Public Works Committee

Public Works Committee Meeting Minutes (DRAFT) September 8, 2020

The purpose of the October 13th Public Works meeting is to provide a recommendation to the Village Board regarding the Final Plat, in particular those aspects of the final plat related to transportation and stormwater facility layout and design.

We have received the set of documents included in the August 27, 2020 Final Plat Submittal for proposed new residential development slightly south of CTH MN, north of the railroad tracks and west of CTH AB for a project called Rosewood Fields. The plans and stormwater management report have been reviewed from a public works perspective. Our comments are shown below, organized by the appropriate document and/or drawing sheet number.

PUBLIC DRAINAGE EASEMENT DETAIL
NOT TO SCALE
SEE NOTE 1

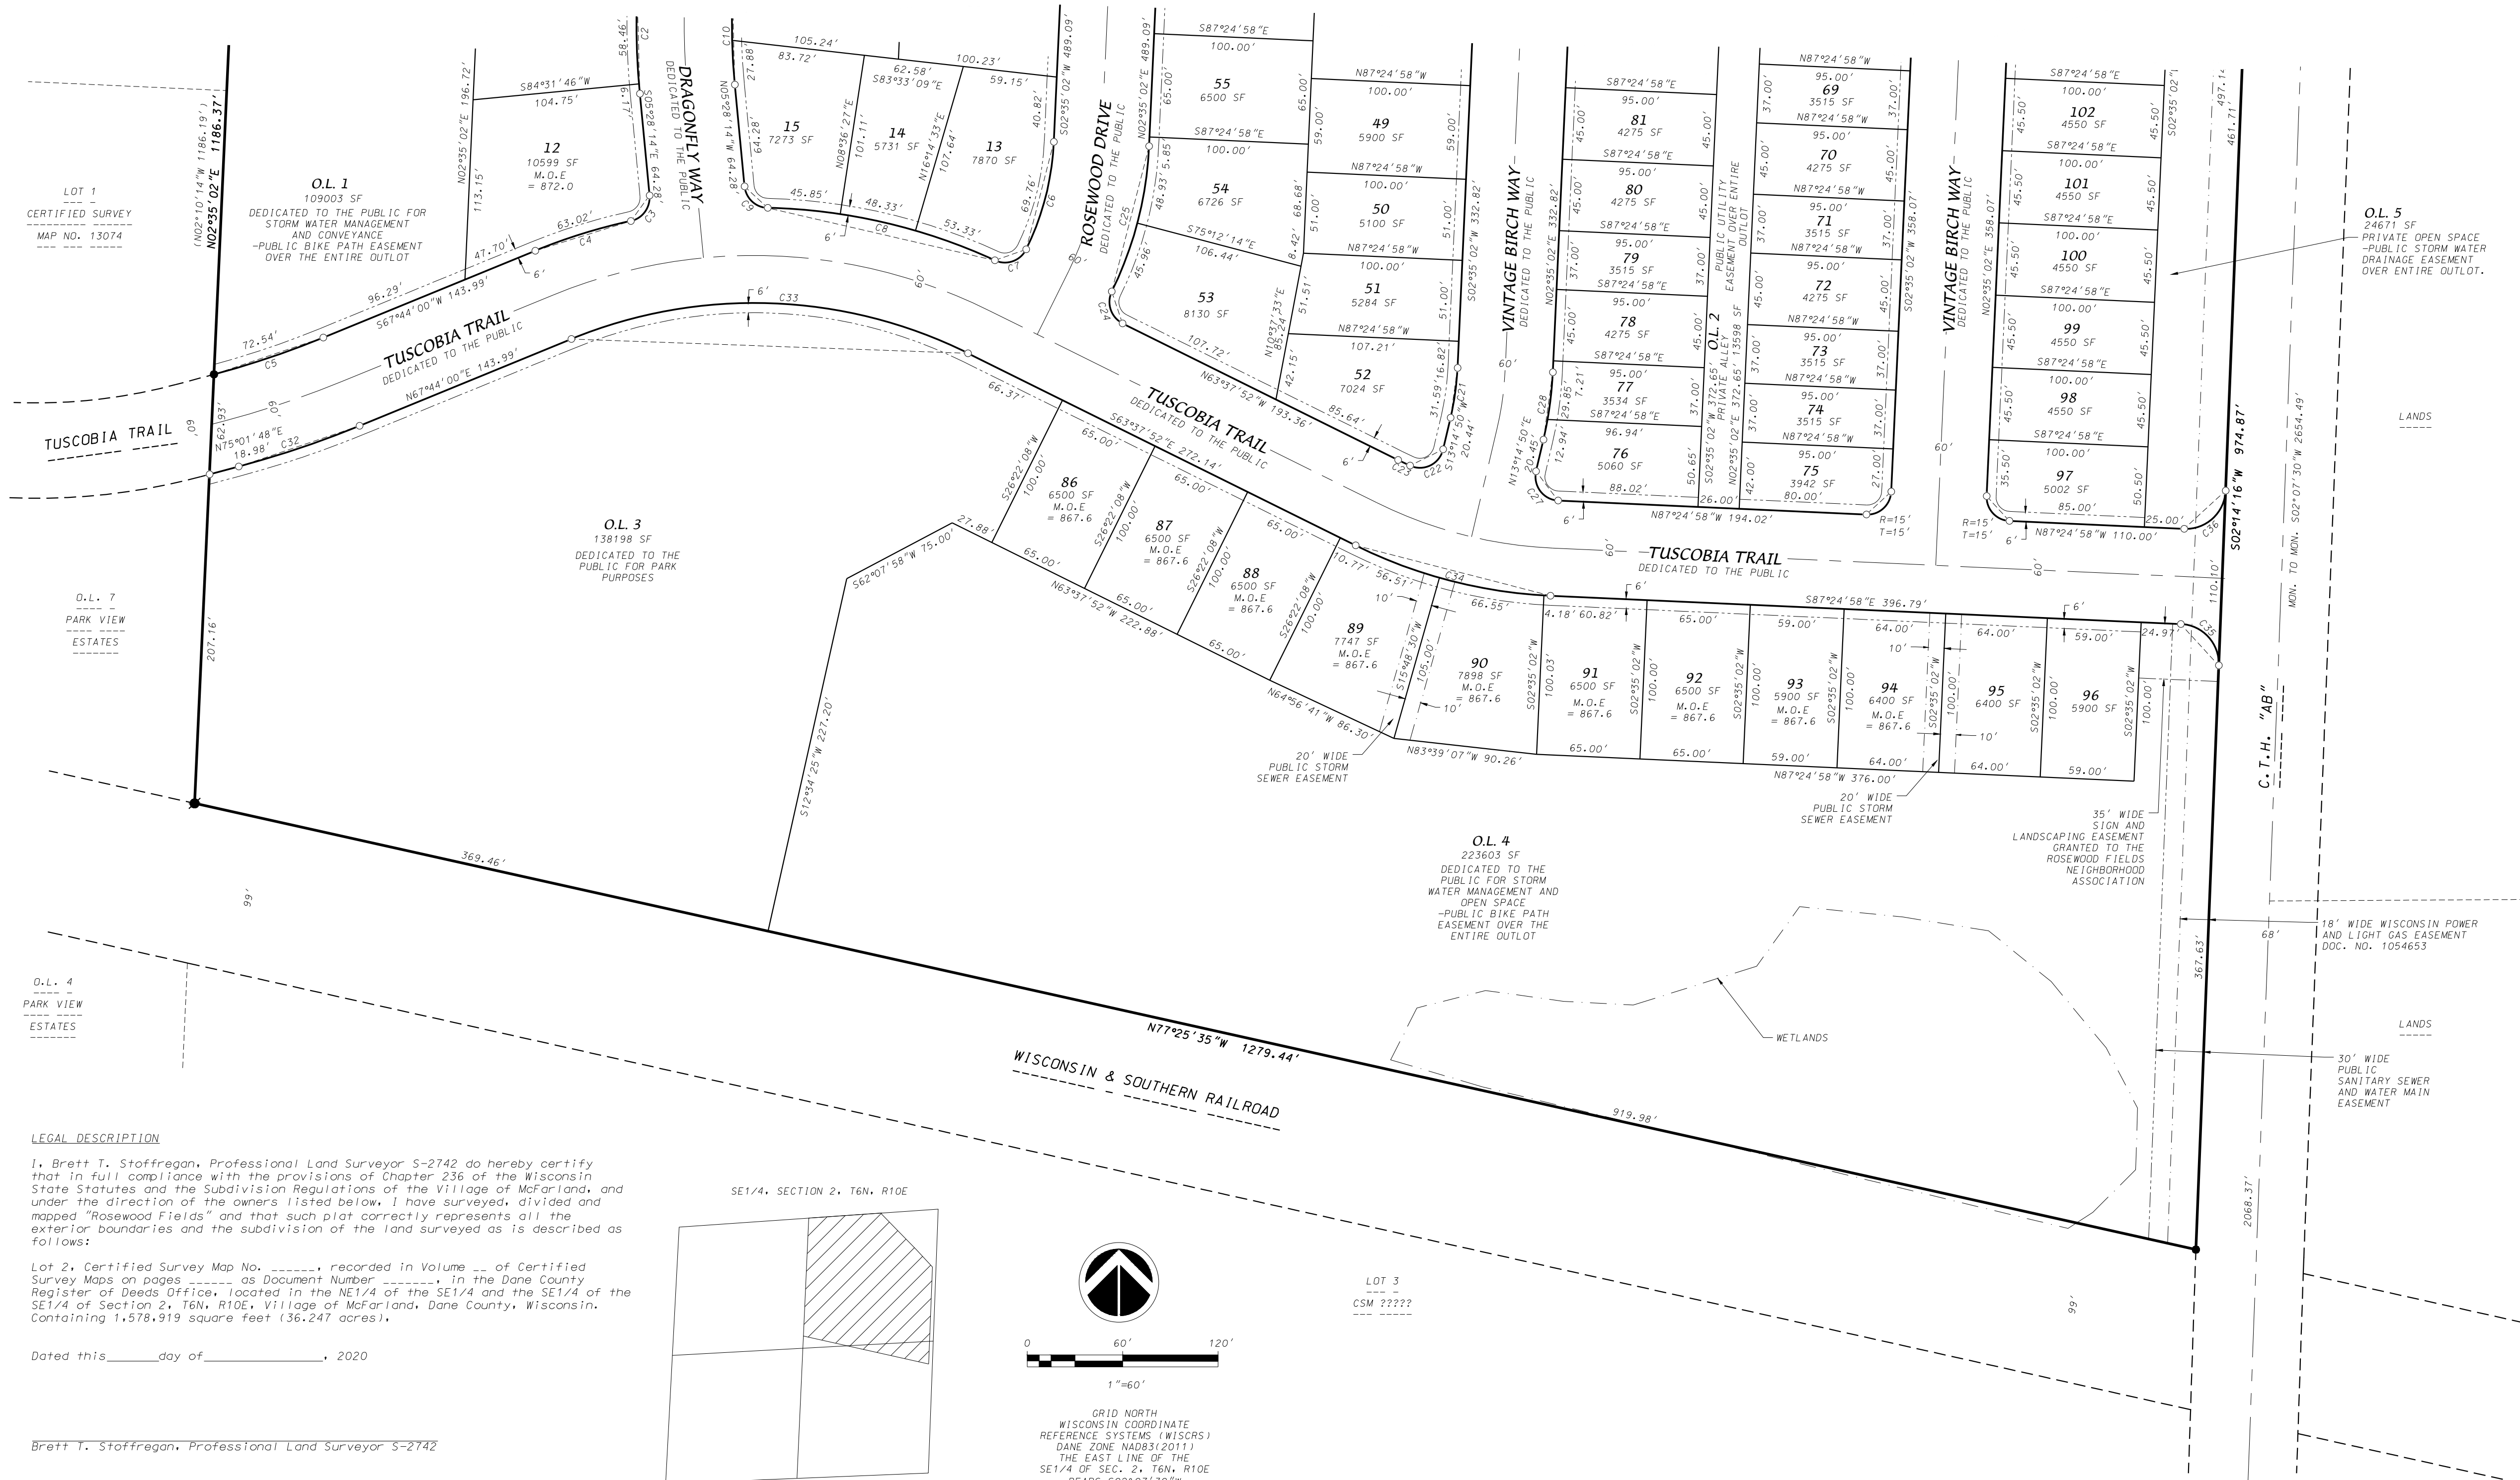
The note about lowest building opening elevations should be expanded to include all parcels that abut stormwater conveyance and management areas. Instead of referring to the approved stormwater management plan, the actual elevations for each affected lot should be shown on the plat itself to make it easier for future homeowners (and the Village) to confirm openings.

The Public Drainage Easement Detail refers to an incorrect note. This can be cleared up with note that states: “There shall be no changes in drainage or elevations with the easements for drainage purposes without the written approval of the Village of McFarland.”

Sheet Number:
 3 of 26

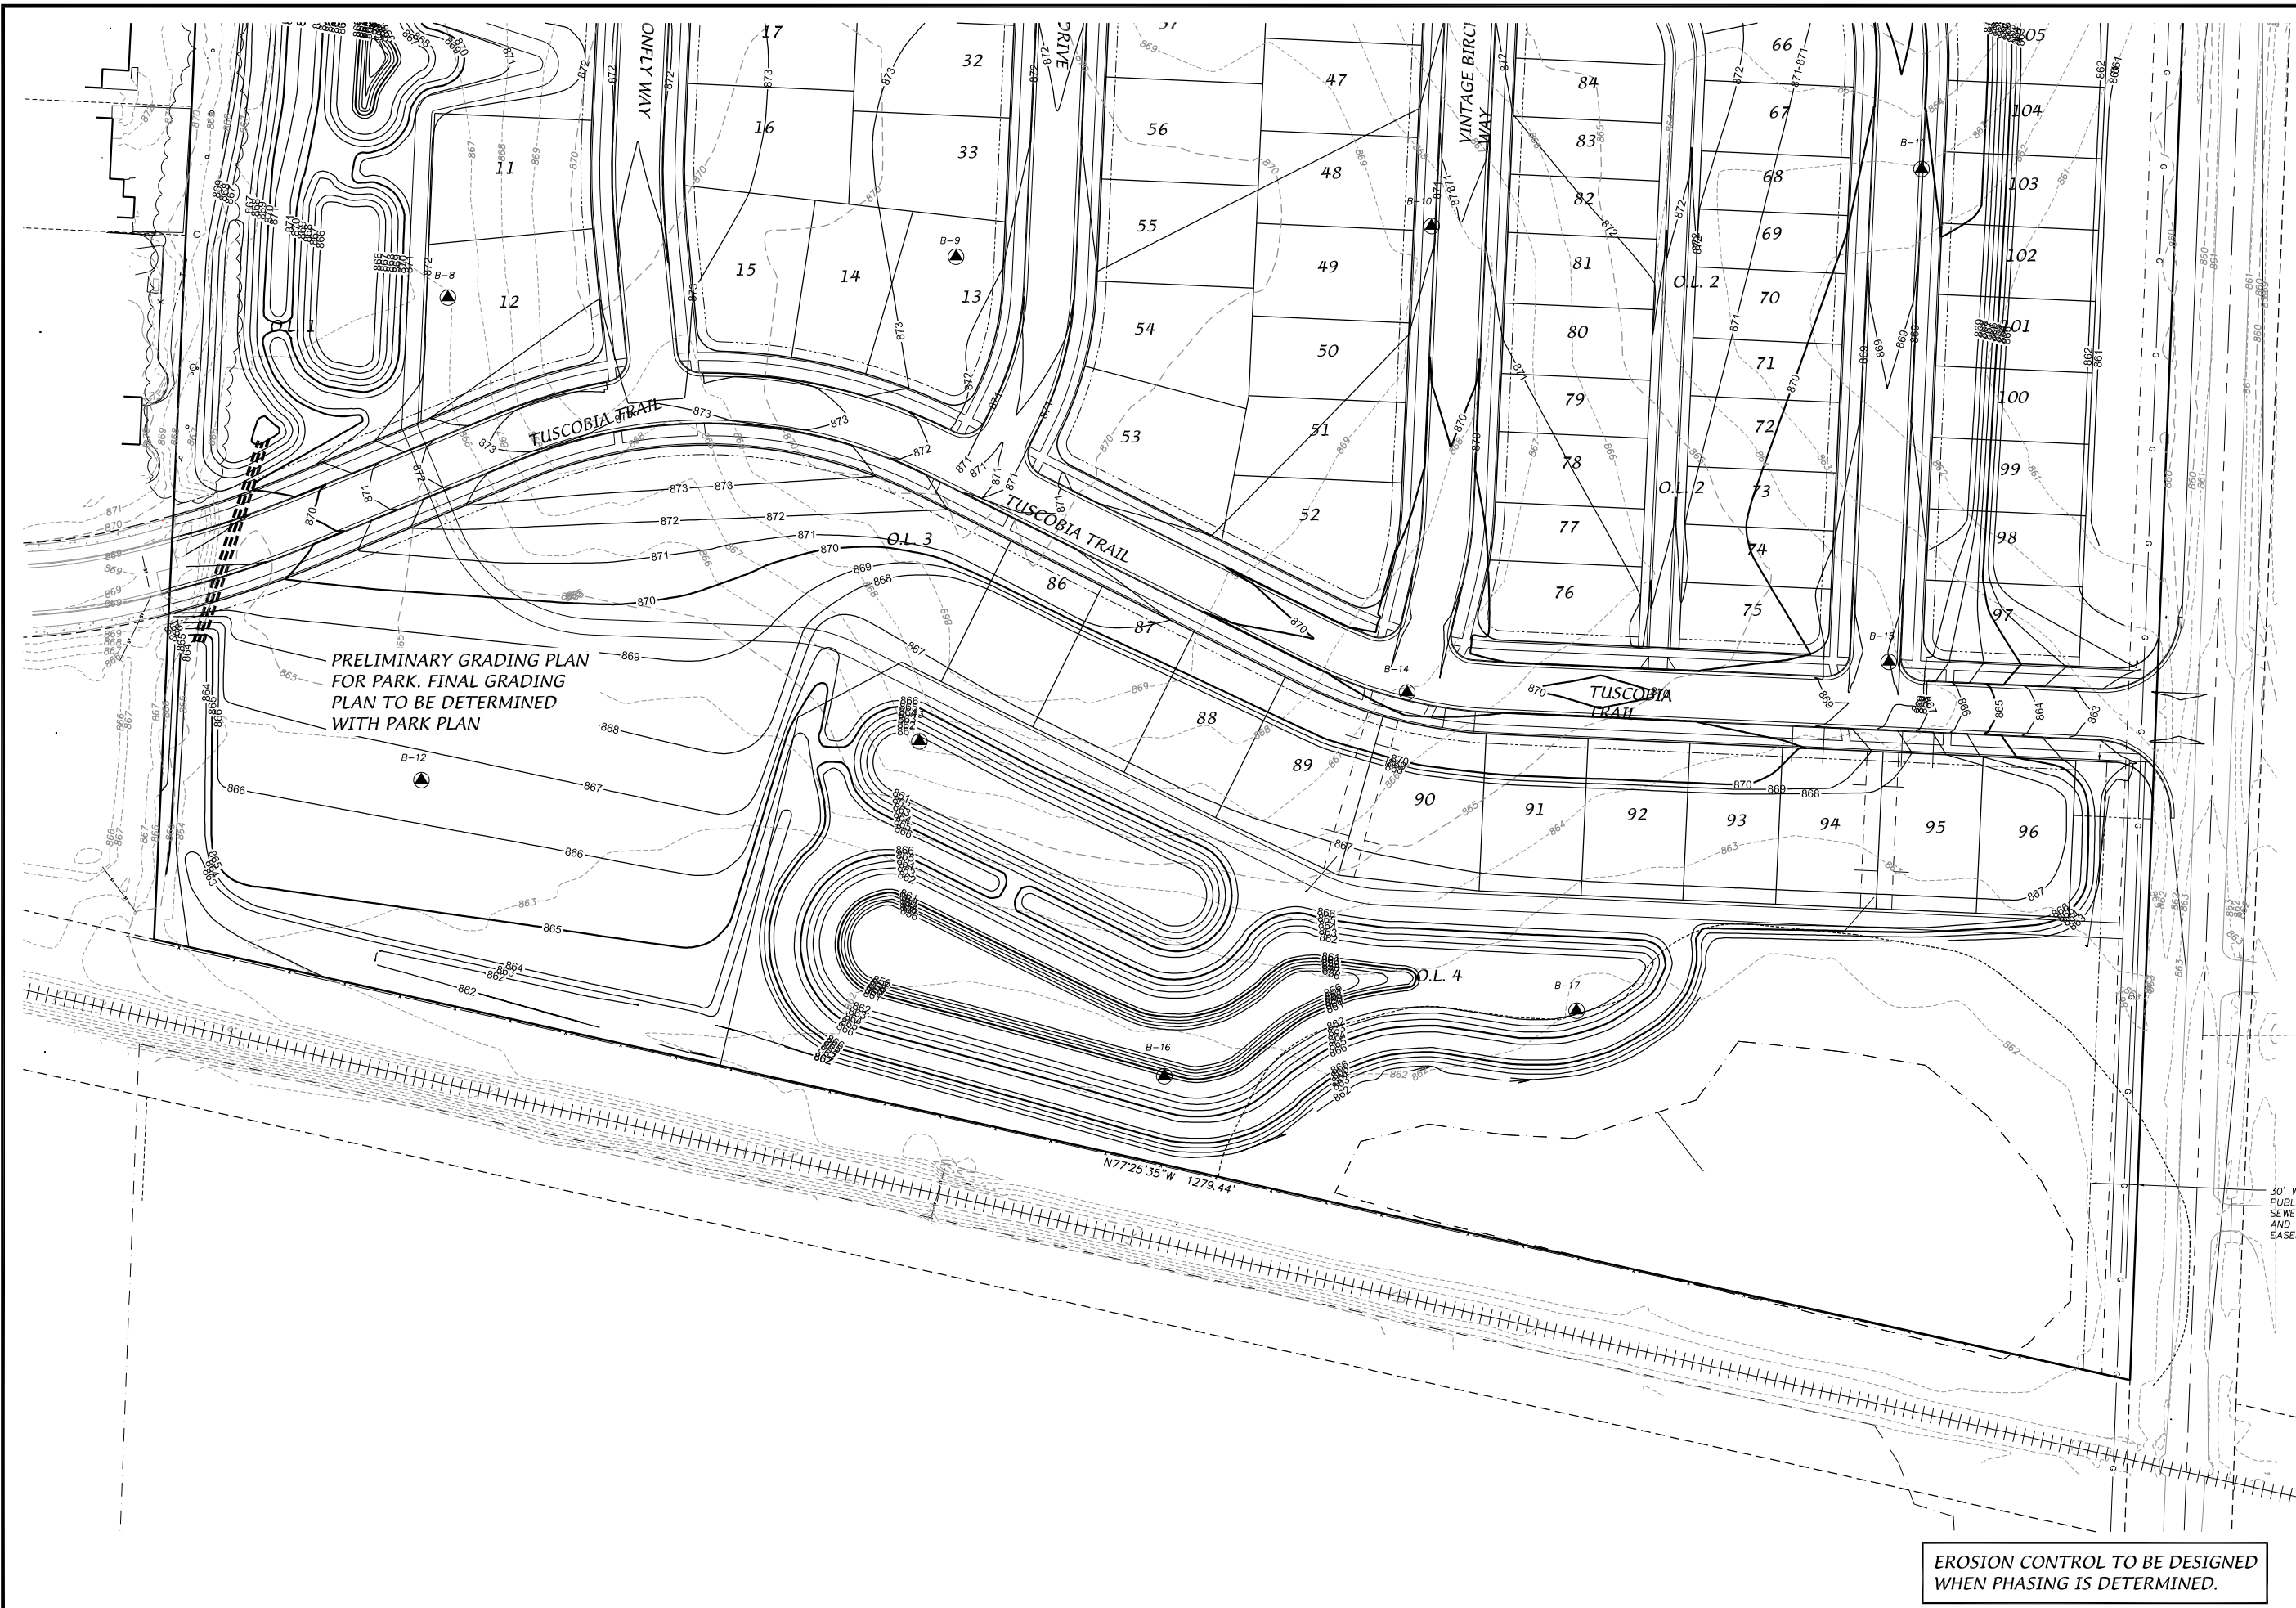
- The proposed right-of-way width is 60 feet, consistent with Village minimum standards and also recent residential streets. This will allow for on-street parking on both sides of the street and ample (7.5 foot) terrace space for tree plantings, if desired.
